Product hierarchy no.				Part no.	SBU	Product Type	Customer part no.
SBU	PG	PUG	Type				
01	002	060	0000000684	0853.9561 0853.9562	Circuit Protection	OG Cover

Product Change Notification					PCN OG Cover Change of product design		
owner	creation date	release date	released by	change order	rev	page	
lutzjo	26.01.2023	03.04.2023	schulejo		A	1 of 2	D10-070-948

Current product appearance	New product appearance

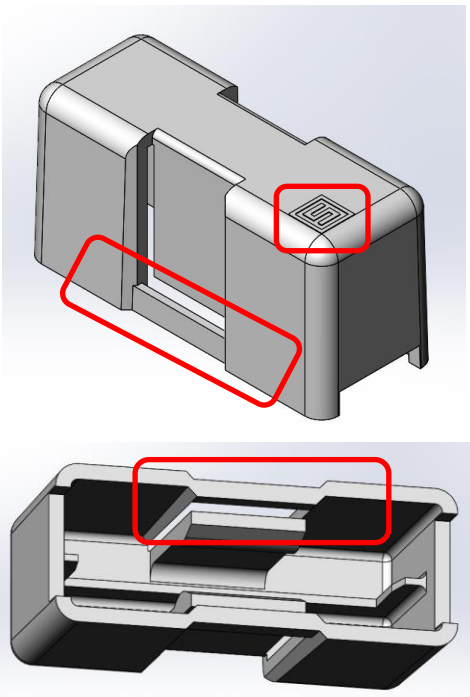
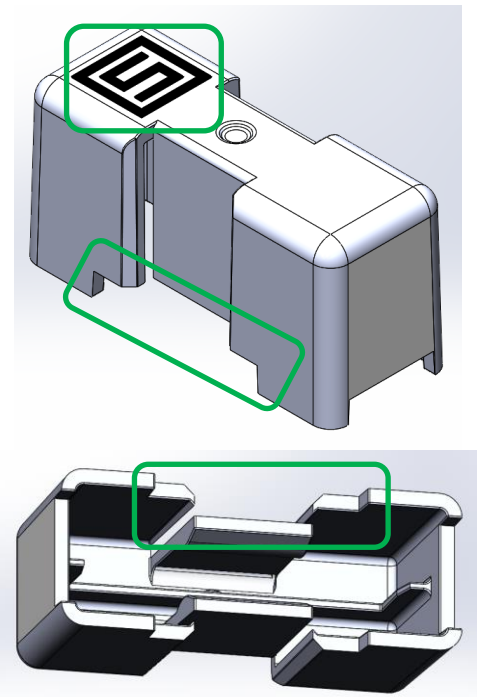
- Outside dimensions remain the same
- Position and size of SCHURTER logo changed
- Bridge on both sides removed

- Production process improvement
- Improved moulding process to avoid flow lines
- Improved legibility of the product markings

<input checked="" type="checkbox"/>	Form	Consider new product design and new position of product marking. Outside dimensions remain the same.
<input type="checkbox"/>	Fit	
<input type="checkbox"/>	Function	
<input checked="" type="checkbox"/>	Manufacturing	No action required, new moulding tool
<input type="checkbox"/>	Label	
<input type="checkbox"/>	Packaging
